Subject ▶ Change on armature assembly

For Models ▶ 9035SB, 9035, M902 (Finishing Sander)
9035N, M903 (Dual Action Finishing Sander)

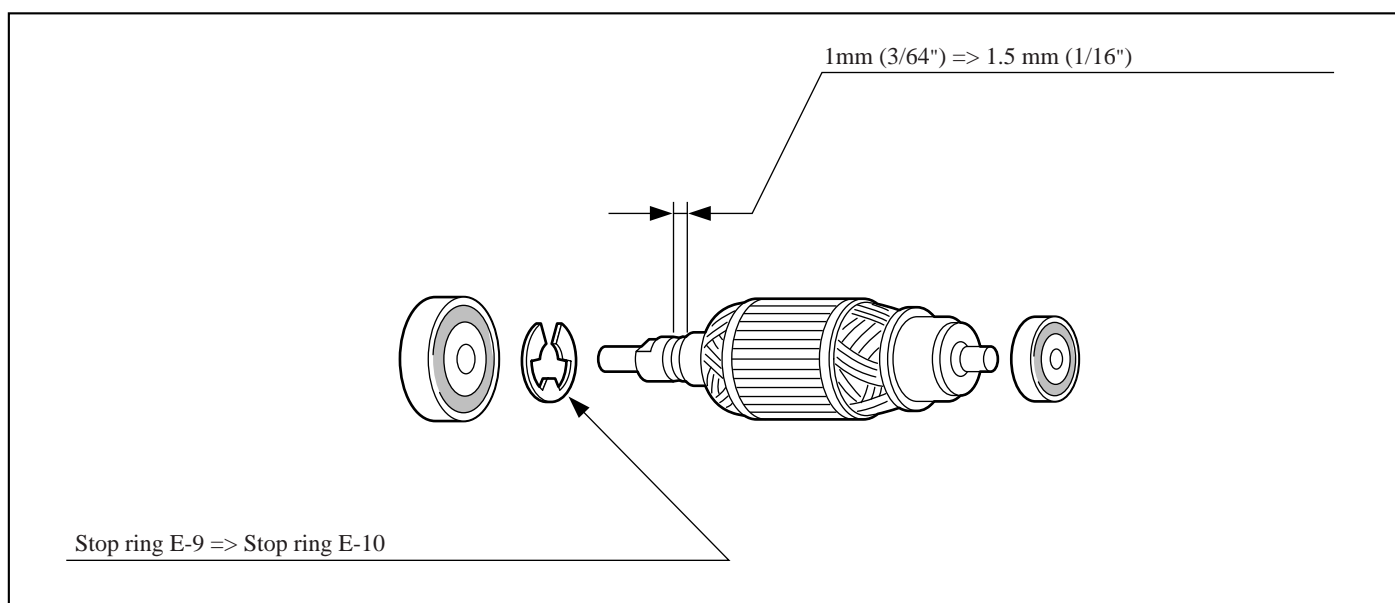
Description ▶ The armature assembly will be changed as follows. However, Its part No. will remain unchanged.
 1. The stop ring E-9 (a component part of armature assembly) will be replaced by a stop ring E-10.
 2. The groove in the armature shaft will be widened from 1 mm (3/64") to 1.5 mm (1/16").
 However, the part No. of armature will remain unchanged.

Item No.	Current part		Q'ty	I/C	New part		Q'ty	Note
13	Stop ring E-9 961015-1		1	No	Stop ring E-10 961016-9		1	Interchangeable when replaced together with respective armature
